Scott Horsley
Water Resources Consultant
65 Little River Road • Cotuit, MA 02635 • 508-364-7818

17 August 2020

RE: 518 South Avenue, Weston, MA

Figure 1 - Pre-development Water Table

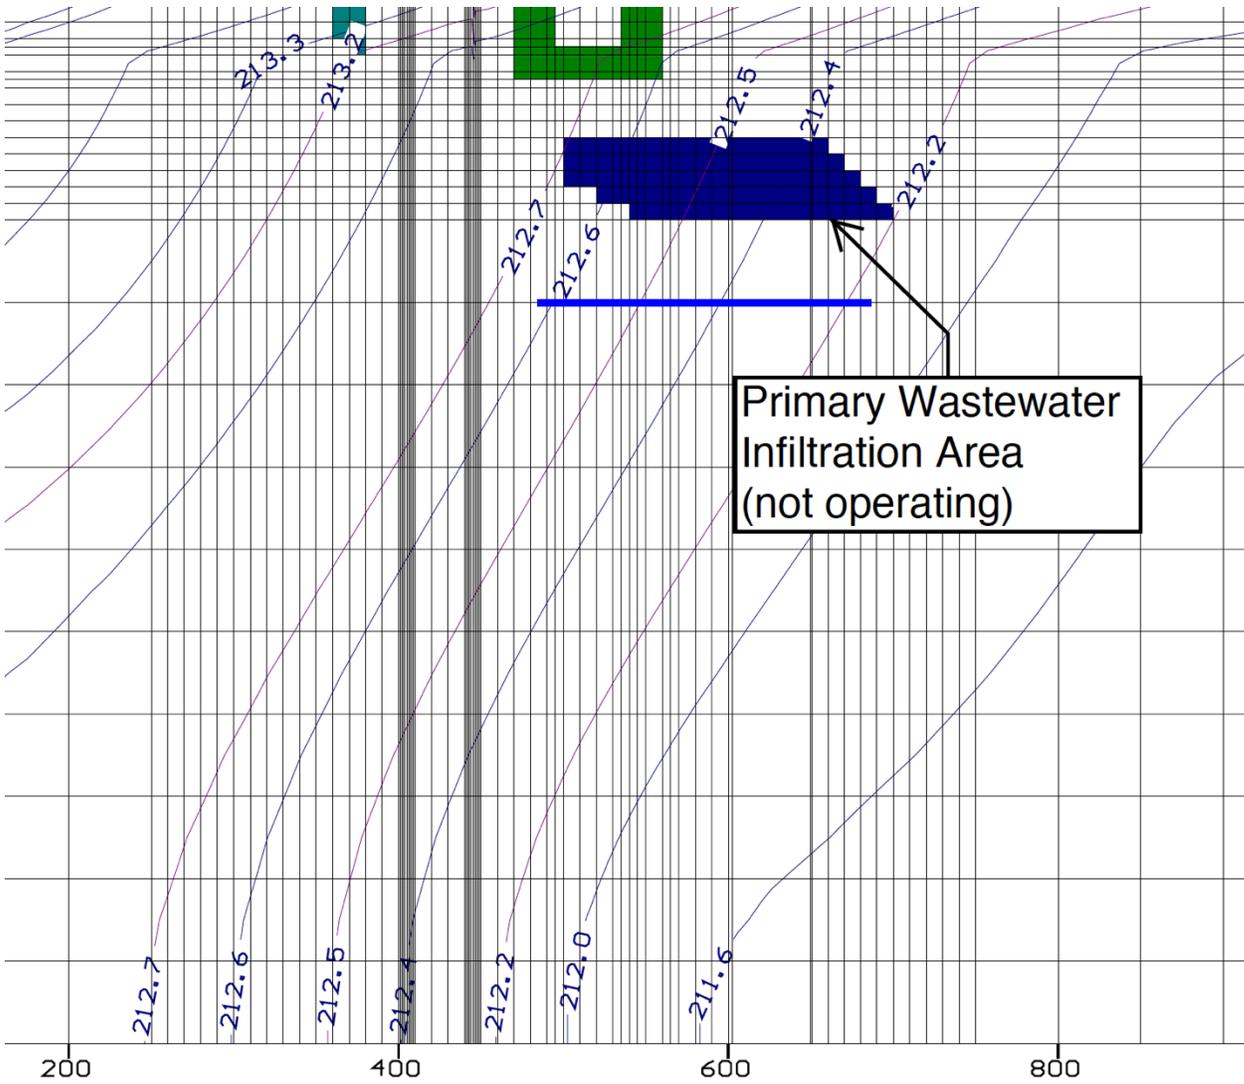
Notwithstanding the previous comments, the groundwater mounding analysis does show alterations to the adjacent bordering vegetated wetland (BVW). Appendix F Groundwater Mounding Documentation includes three figures that present the findings of their mounding analysis and modeling. The first figure shows predevelopment conditions (with the stormwater and wastewater disposal “*not operating*”). The second figure shows post-development conditions (with the stormwater and wastewater disposal “*operating*”). The figures omit the location of the wetland resource areas. Given the jurisdiction of the Wetlands Protection Regulations, the purpose of the NOI, and the role of the Conservation Commission this would seem to be critical information for your review.

To assist the Conservation Commission in analyzing these modeling results on the jurisdictional wetlands I have added the approximate location of the BVW boundary that is located 50 feet to the east of the wastewater disposal area (see blue line in the following figures). Please note that east on these figures is to the bottom of the figures. To determine the hydrologic alterations on the BVW I have compared the modeled water table elevations at the BVW under both pre-development and post-development conditions. This is also not presented or discussed in the NOI. Table 1 summarizes the modeled water table elevations at the BVW boundary under pre- and post-development conditions and the alterations at the BVW.

These water level alterations constitute a significant alteration to the BVW and the stream. They show a six inch rise in water levels at the BVW. According to the MADEP Stormwater Handbook these water level alterations in wetlands are not allowed. MADEP Stormwater Manual, Volume 3, Chapter 1, page 17 provides guidance on how to evaluate impacts on wetlands associated with proposed infiltration/recharge

Figure 2 - Post-development Water Table

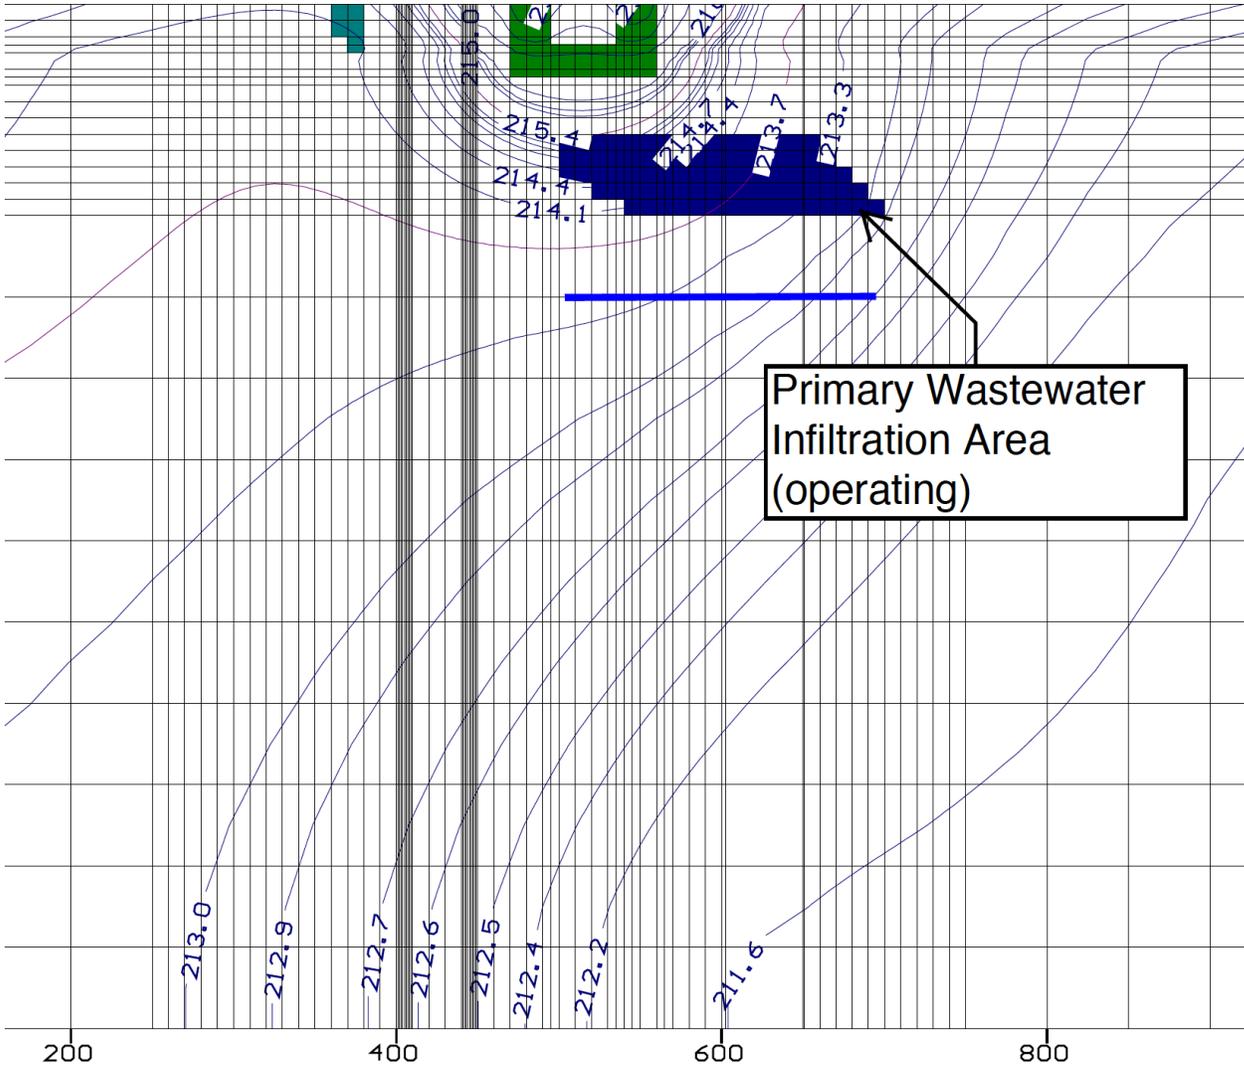
Water Table Contour	Pre-development	Post-development	Alteration
1	212.6	213.2	+0.6
2	212.5	213.0	+0.5
3	212.4	212.9	+0.5
4	212.2	212.7	+0.5
